ADDENDUM NO. 4

NOVEMBER 11, 2026

CITY OF HIGHLAND VILLAGE

HIGHLAND SHORES BOULEVARD
RECONSTRUCTION PROJECT
From Twin Coves Drive/Hillside Drive to 200'± West of Lake Cove

HIGHLAND SHORES BOULEVARD RECONSTRUCTION PROJECT
(FROM TWIN COVE DRIVE/HILLSIDE DRIVE TO 200'± WEST OF LAKE COVE)
DRAINAGE - PLAN AND PROFILE
LINE "SD-F" AND LINE "SD-G"
CITY OF HIGHLAND VILLAGE

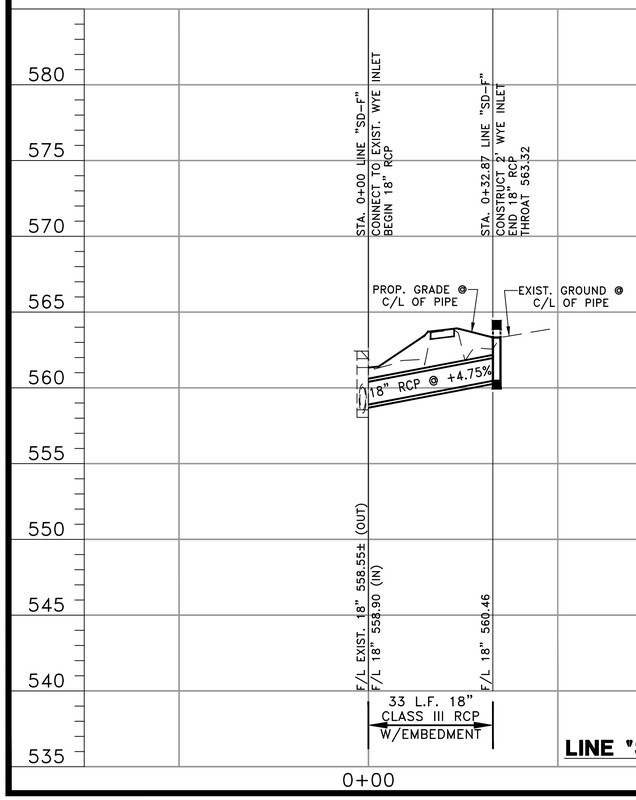
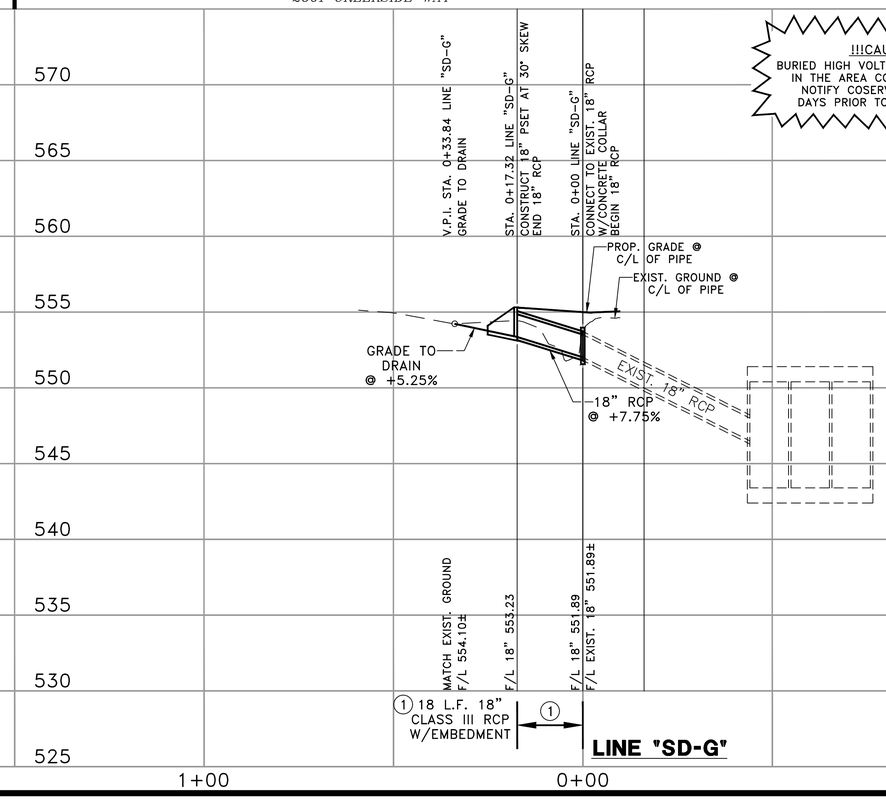
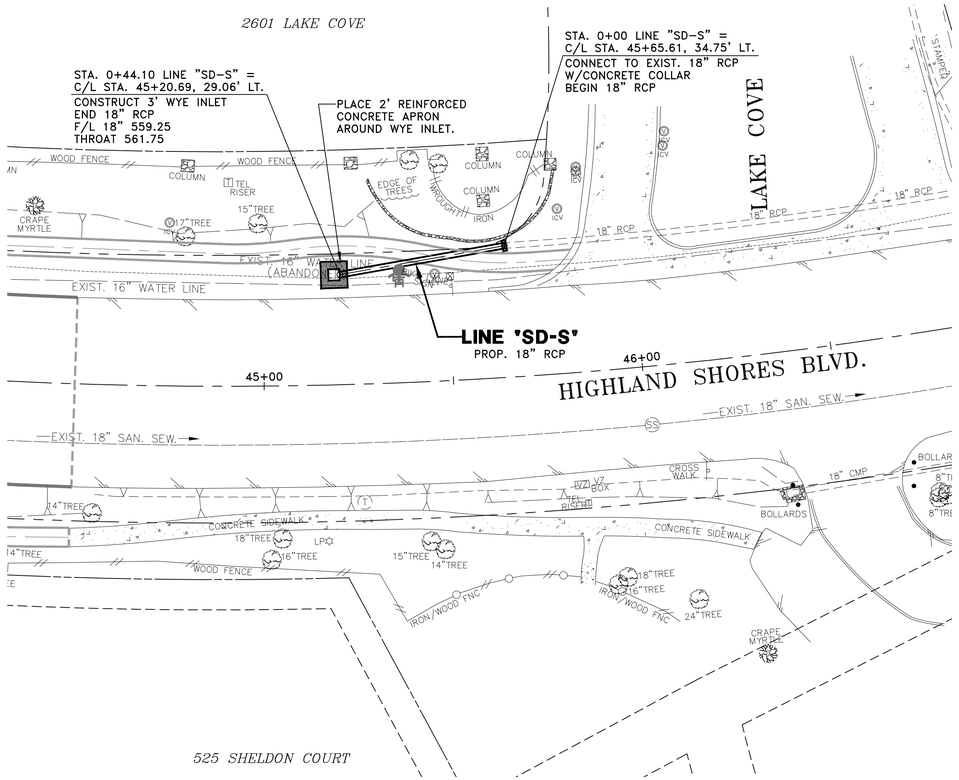
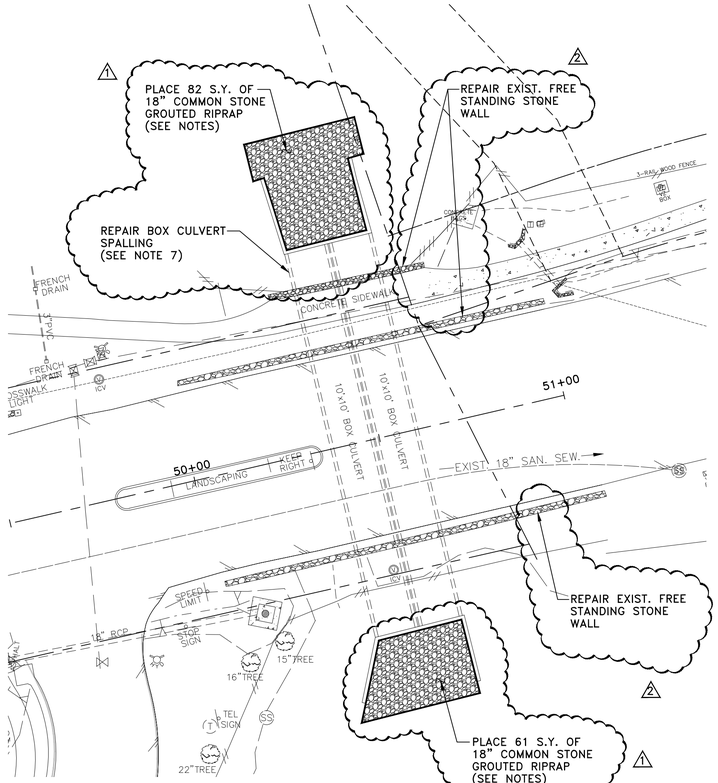
9. Replace Drainage Plan and Profile Sheet No. 100 and Sheet No. 110 with Attached Sheets.

NO.:	DATE:	REVISION:	REVIEWED:
6			
5			
4			
3			
2	11/11/26	STONE WALL	JDW
1	10/26/26	RIPRAP/BOX CULVERT	JDW
